Dogger Bank South Offshore  
Wind Farms

Project Change Request 2 – Onshore Substation  
Zone

Document Reference: 10.53

Revision Number: 01

**DRAWING TITLE**  
**Figure 5 (b) – Works Plan (Onshore Converter Station(s)) – Proposed Change**

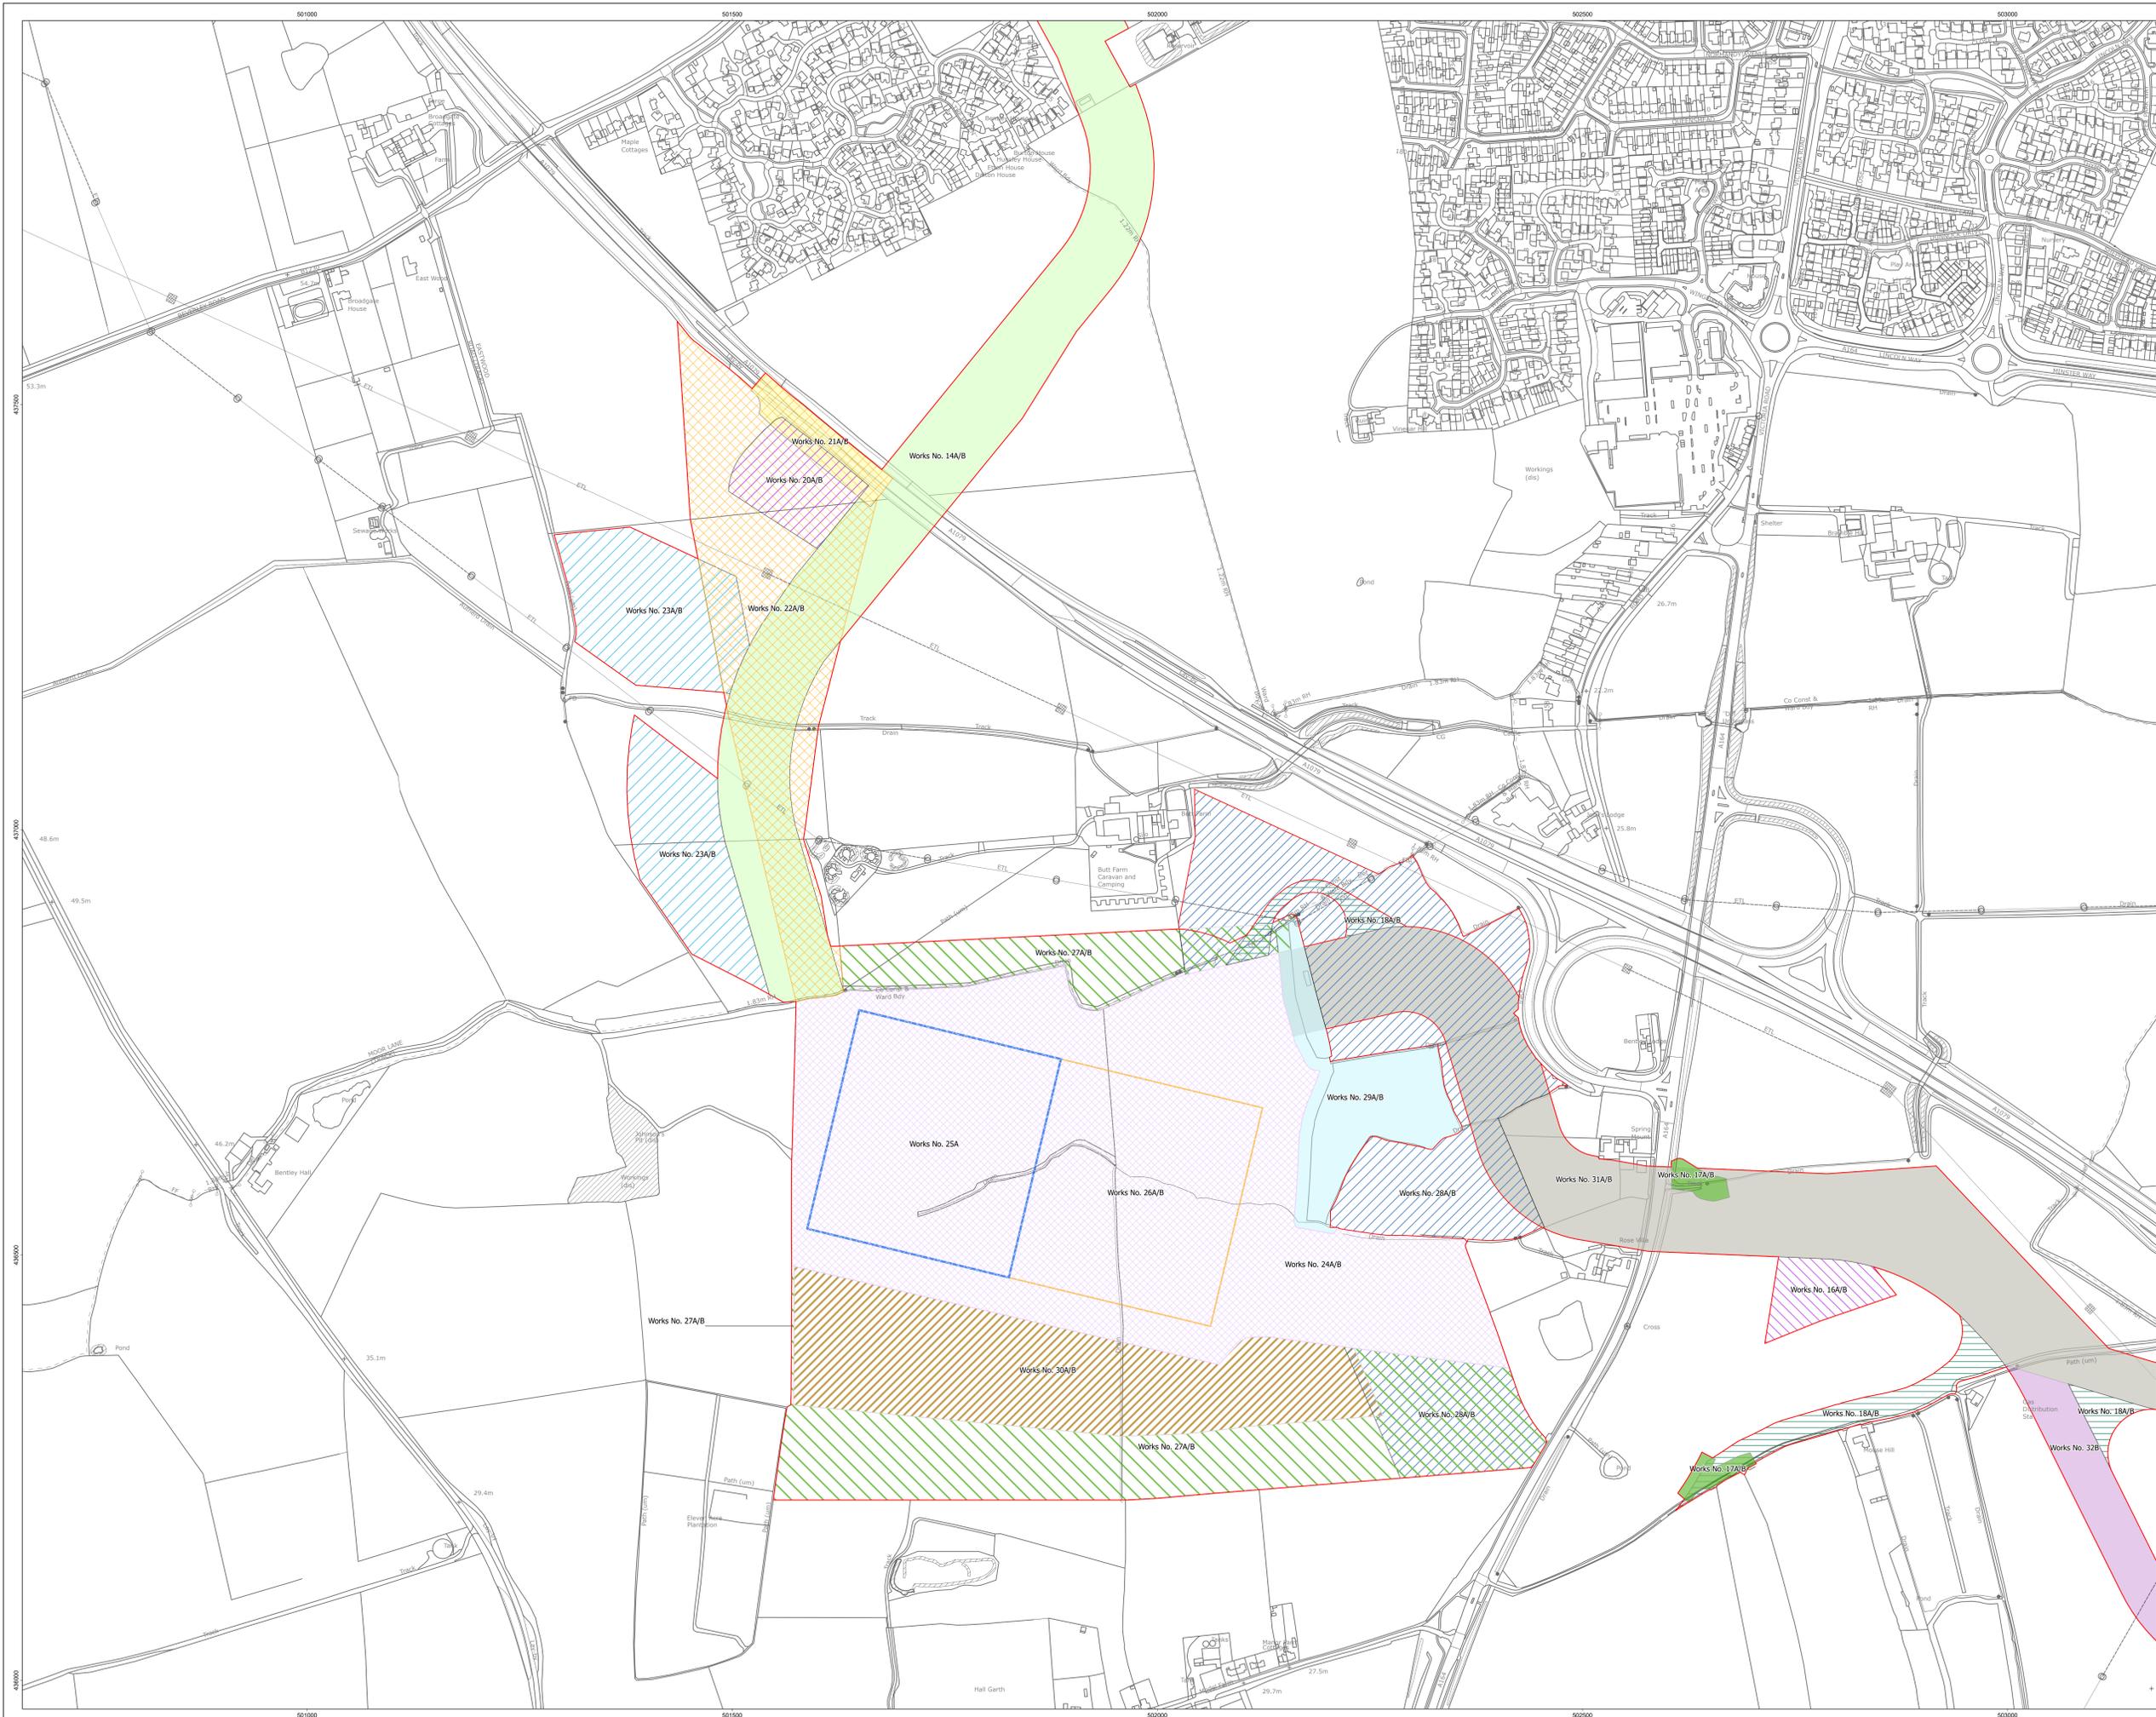
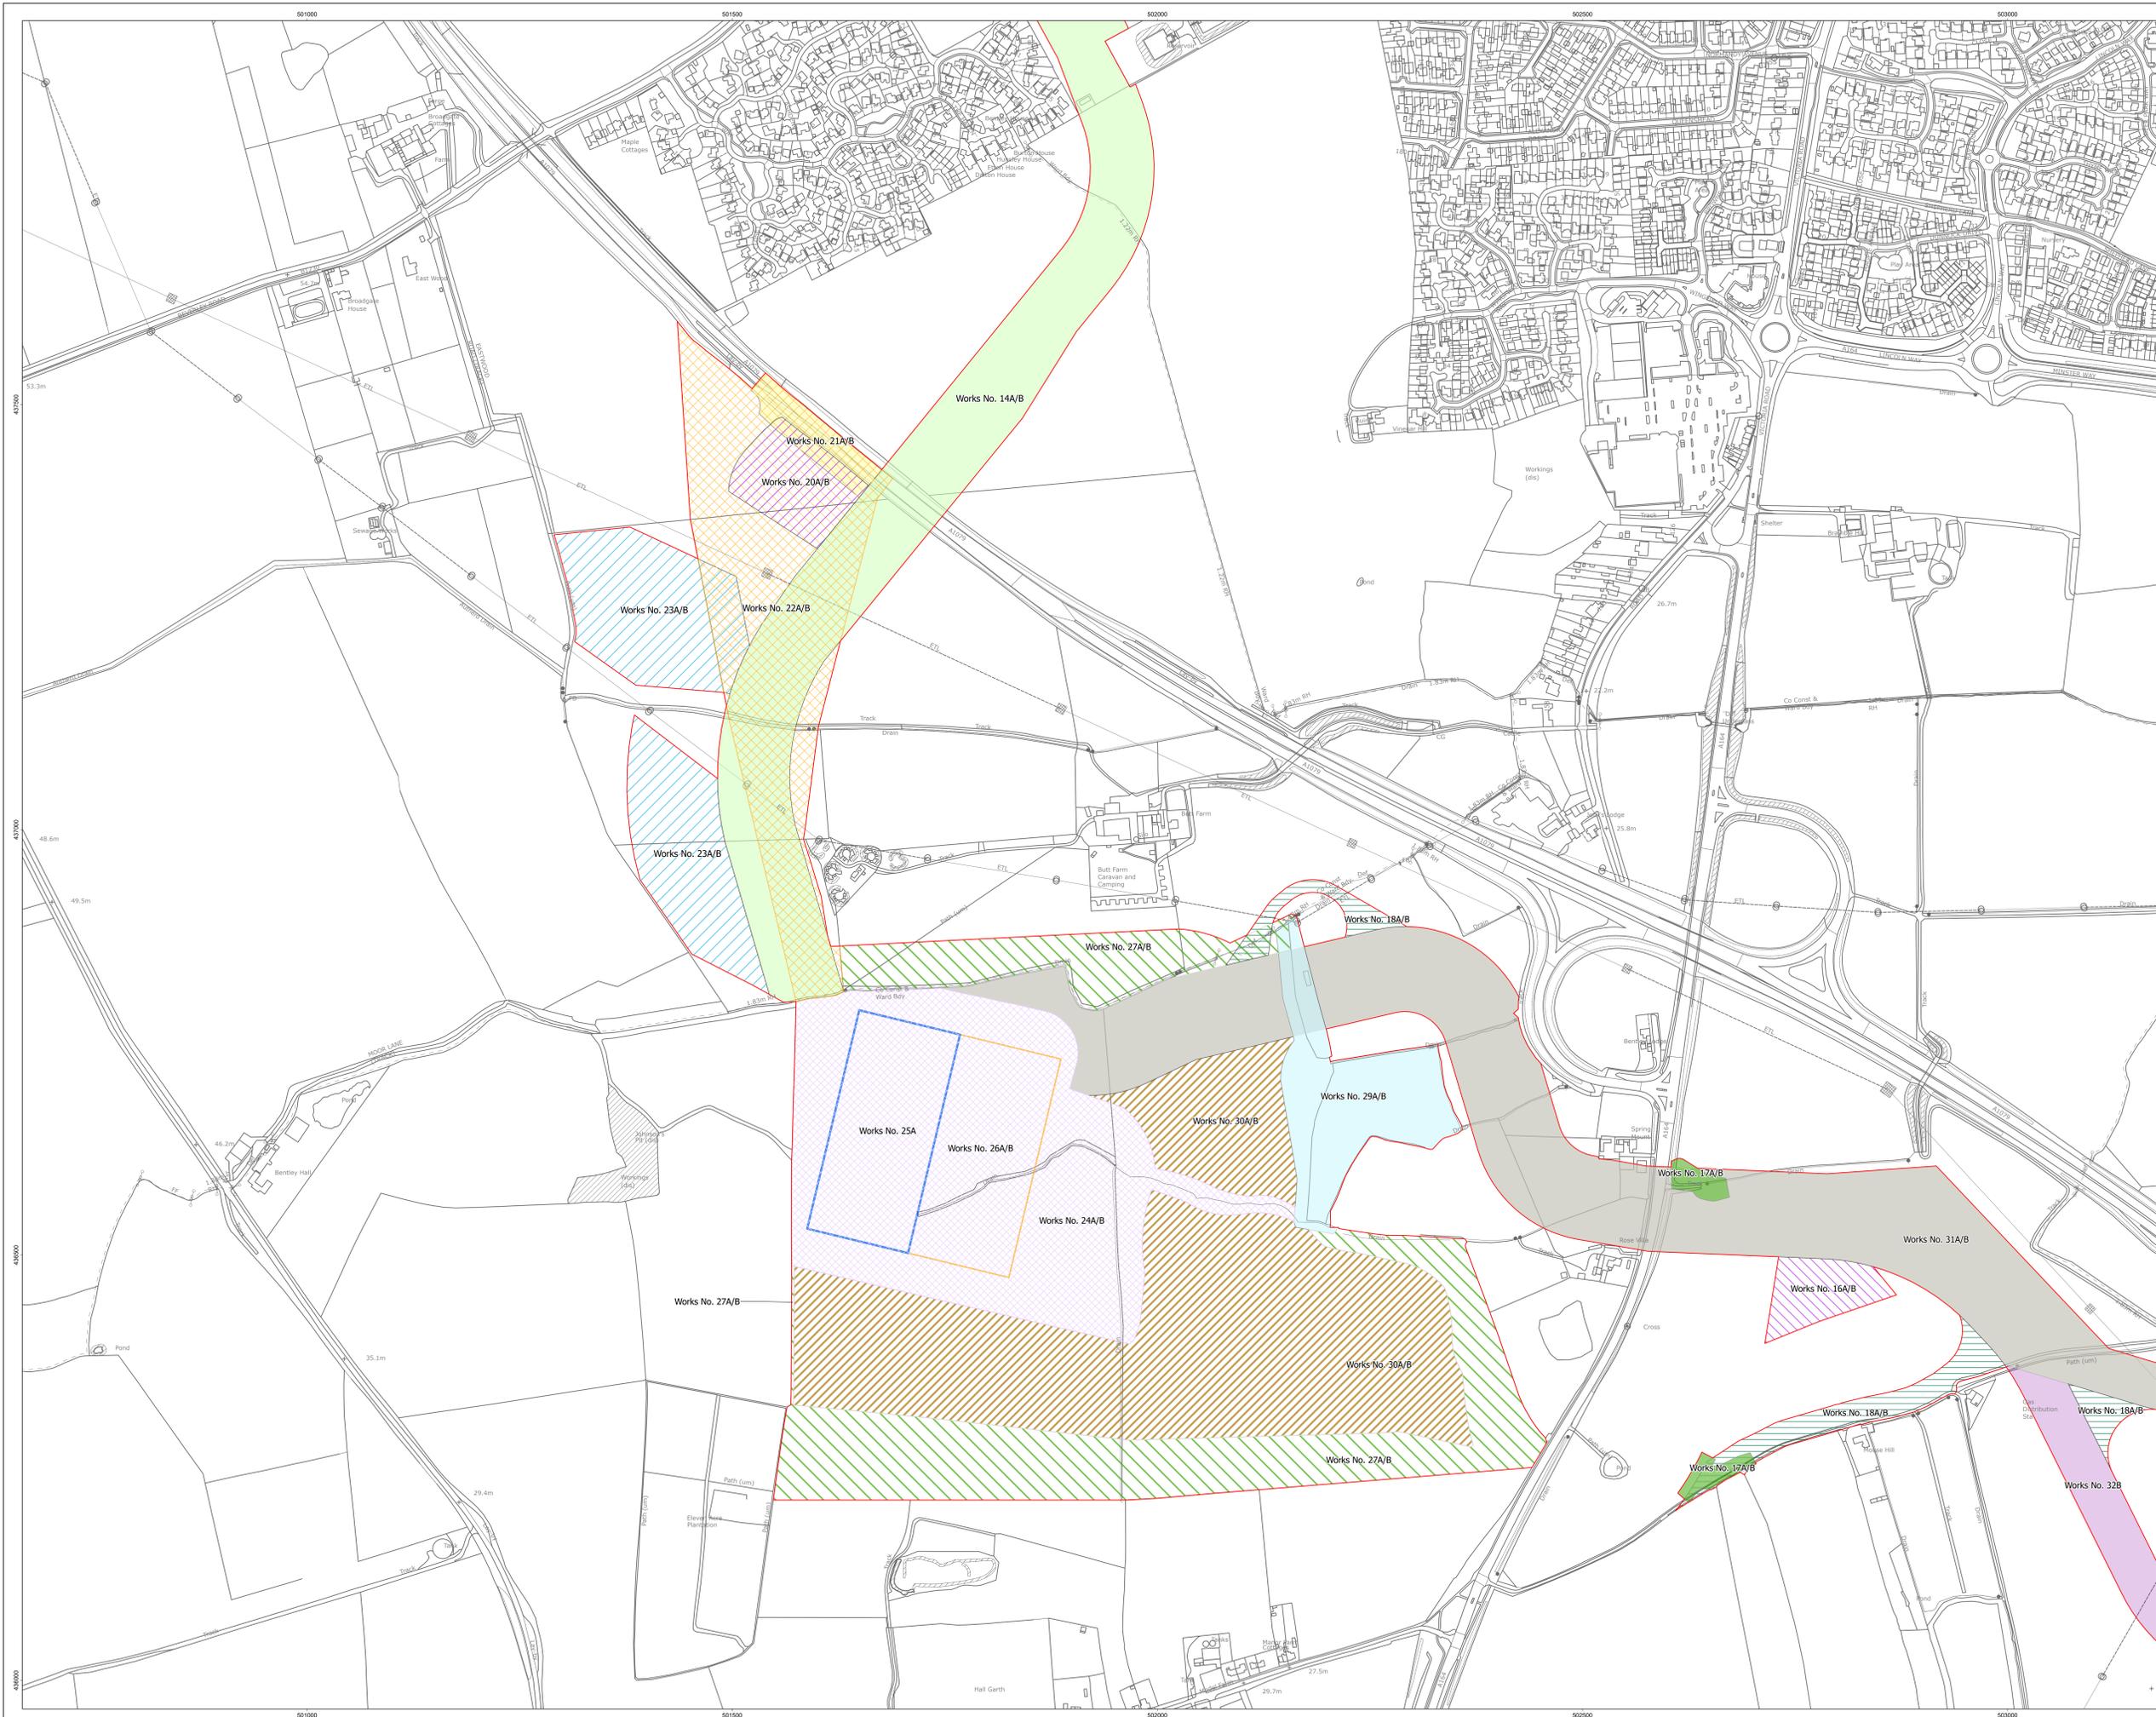
- Figure 5 (a) – Works Plan (Onshore Converter Station(s)) – Submitted with the DCO Application; and
  - Figure 5 (b) – Works Plan (Onshore Converter Station(s)) – Proposed Change.
14. It should be noted that the Figures included in Appendix A are submitted solely to illustrate the proposed change and are not intended to replace the equivalent plans submitted as part of the DCO Application.
15. The description of the Proposed Change is unchanged from the **Change Notification Letter** [AS-015].
